Mobile Intel[®] Pentium[®] II Processor Specification Update

Release Date: November 2002

Order Number: 243887-046

The Mobile Pentium[®] II processor may contain design defects or errors known as errata which may cause the product to deviate from published specifications. Current characterized errata are documented in this Specification Update.

New Mobile Pentium® II Processor in Mini-Cartridge Package Label with Supplier Matrix Mark Removed

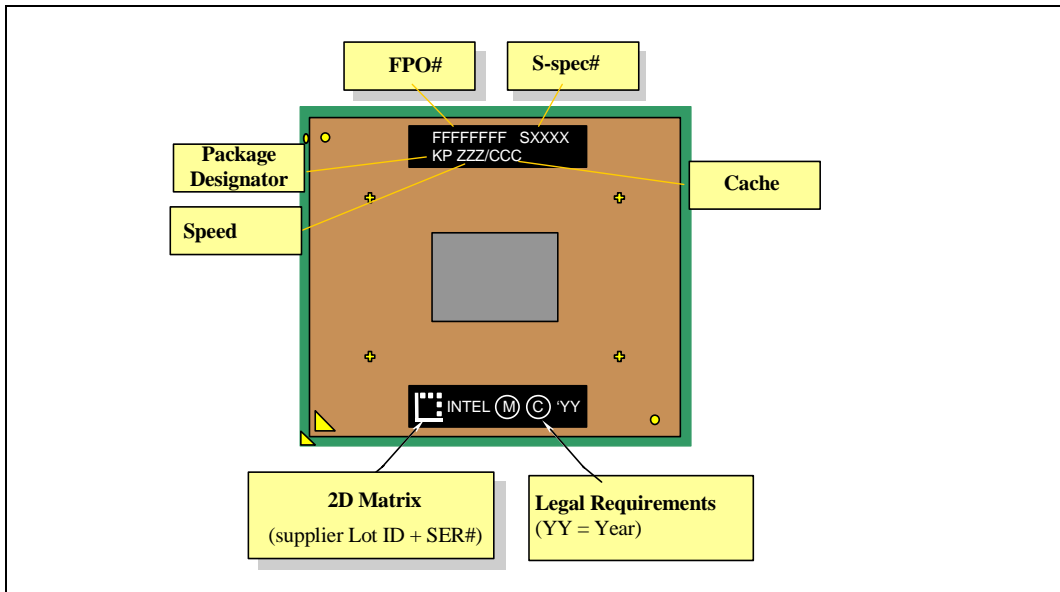
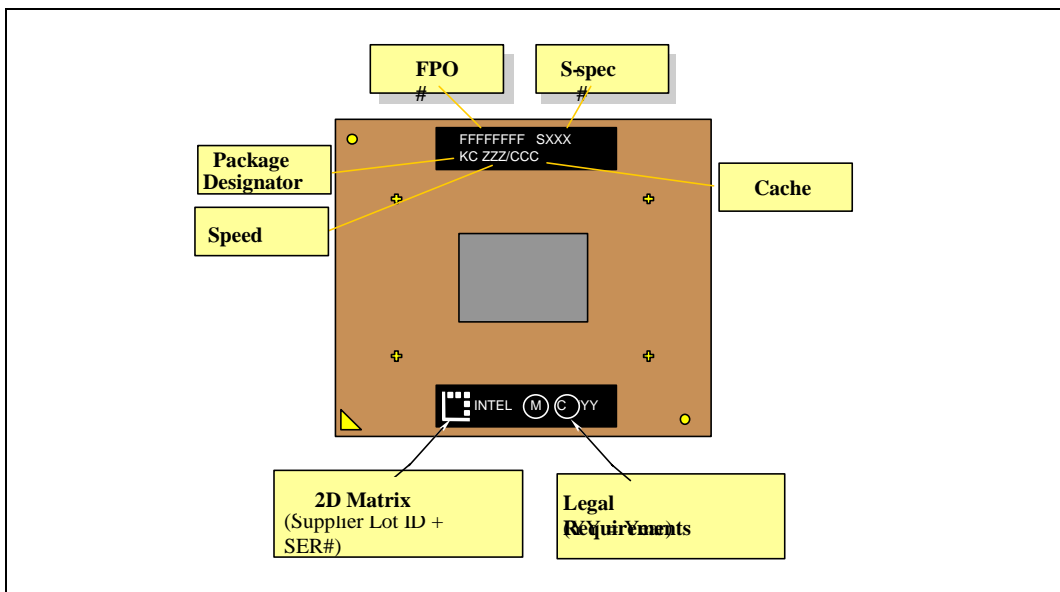
Old Mobile Pentium® II Processor in Mini-Cartridge Package Label with Supplier Matrix Mark

Figure 2. Workaround Flowchart: SMBALERT#-Driven System

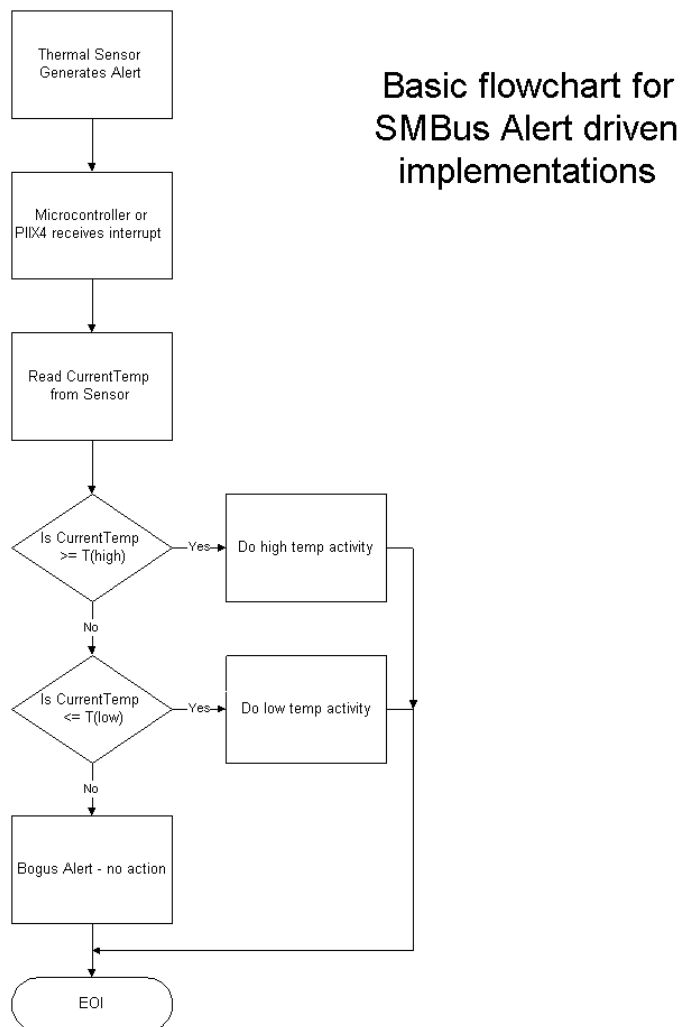
1. Before servicing an interrupt from the thermal sensor, read and compare the processor thermal reading with the threshold limits (T_{HIGH} or T_{LOW}). Figures 2 and 3 provide basic flowcharts for the implementation of this workaround in an interrupt driven system.
2. If the firmware implemented polls the Status Register only, then before taking any action, re-read the temperature register and do a comparison with the alarm threshold limits (T_{HIGH} or T_{LOW}) to determine if the value is actually still within the temperature window.

3. Use a temperature polling scheme to monitor the processor temperature.

Figure 1. TAP Gageable Thread Clarification

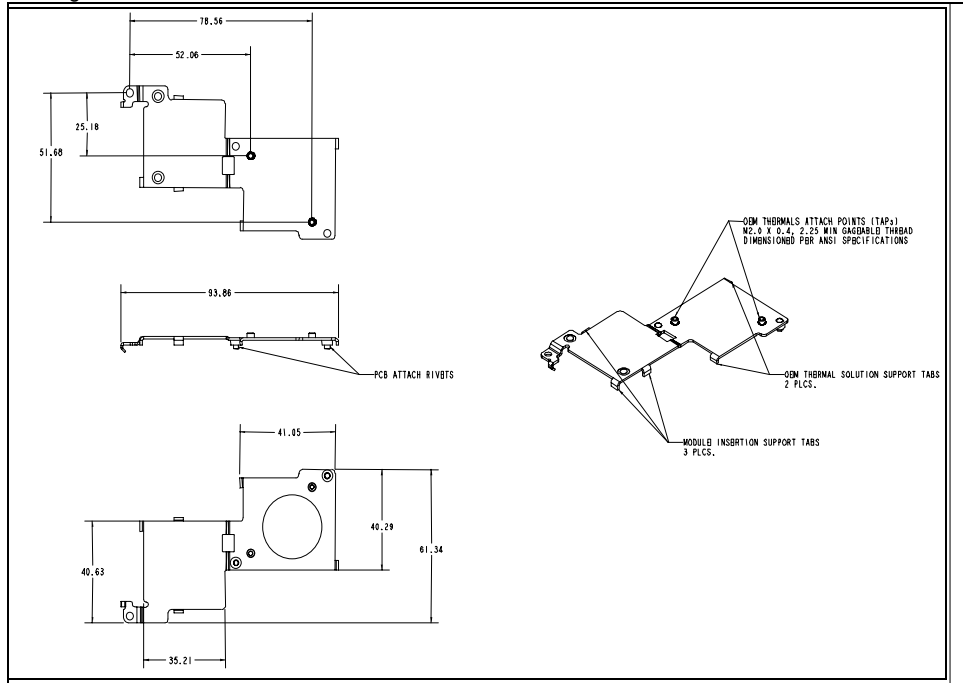
In the *Intel® Pentium® II Processor Mobile Module : Mobile Module Connector 1 (MMC-1)* and the *Intel® Pentium® II Processor Mobile Module : Mobile Module Connector 2 (MMC-2)* datasheets (Order Numbers 243667 and 243668, respectively), the thermal attach point (TAP) gageable thread specification was not clearly identified in Figure 14, of Section 5.2. The following is the TAP clarification:

OEM Thermal Attach Points (TAPs) M2.0 x 0.4, 2.25 min gageable thread dimensioned per ANSI specification.

See Figure 1 below for more information.
